Subject: RATTLING NOISE FROM CENTER SEAT BACK WHEN DRIVING ON ROUGH ROADS	Bulletin No: 09-032/13
	Last Issued: 11/11/2013

2013-2014 CX-5 vehicles equipped with a 4:2:4 split type rear seat with VINs lower than JM3KE*****327345 (produced March 1, 2013)

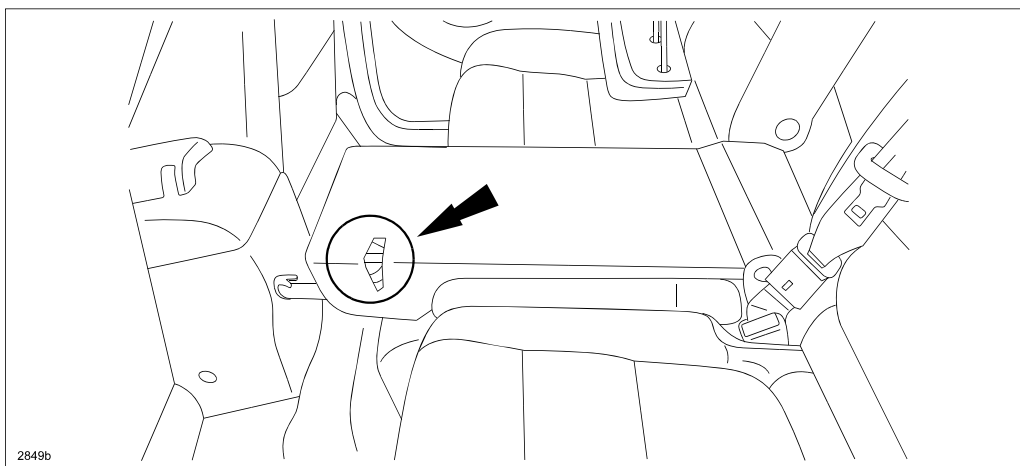
This concern may be caused by a rubber stopper that has come off the rear center seat back bracket. The seat bracket contacts the striker and causes the noise.

The shape of the rubber stopper and center seat back bracket have been changed to eliminate the noise.

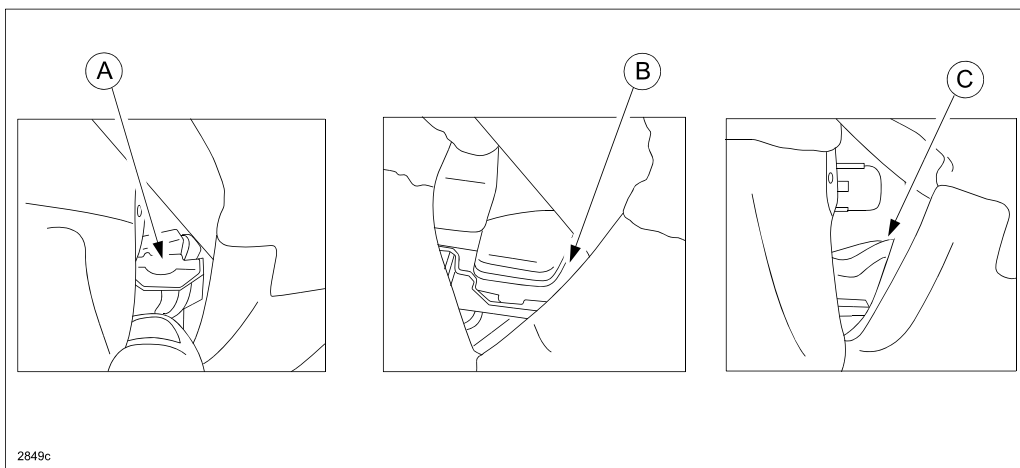
4. If the rubber stopper (A) is loose (B) or has come completely off (C) the seat bracket, replace the rubber stopper it with a new part.

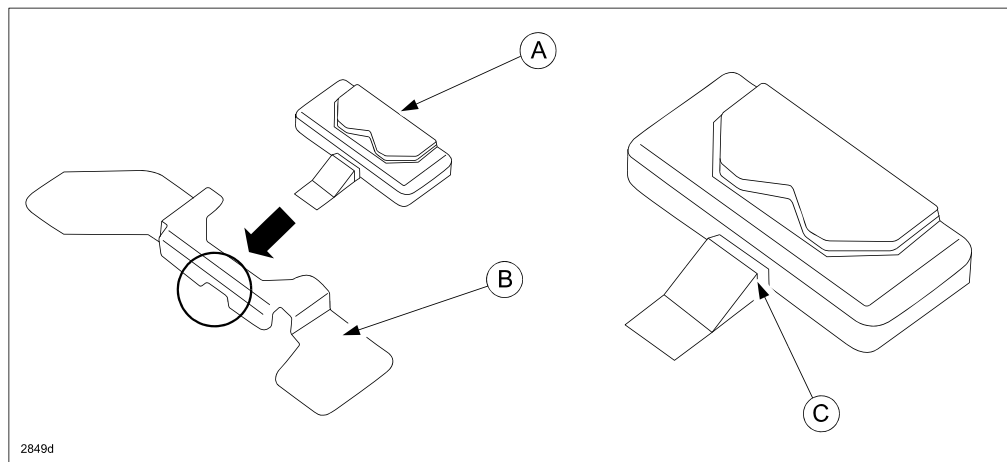
5. Push the rubber stopper (A) into the seat bracket (B) until the edge of the rubber stopper (C) touches the seat bracket.

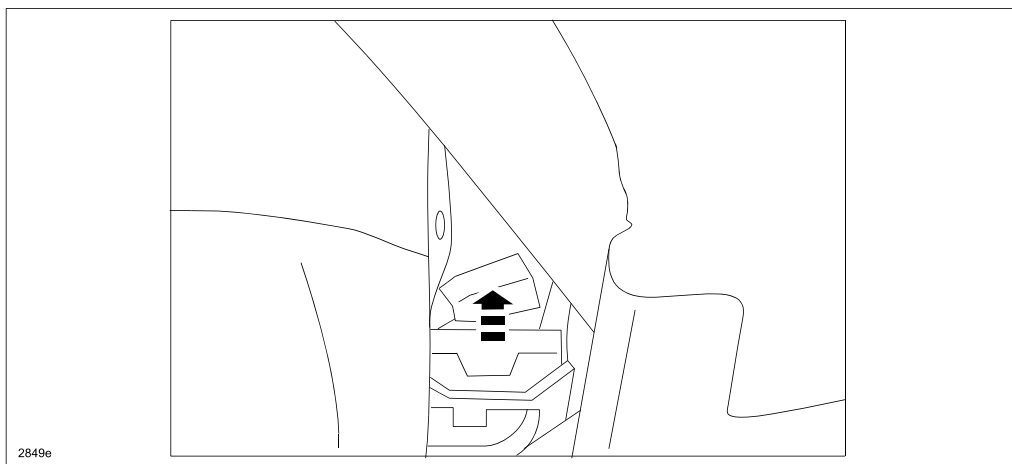
6. Verify the rubber stopper does not come off when slightly pushing it by hand in the direction of the arrow below.
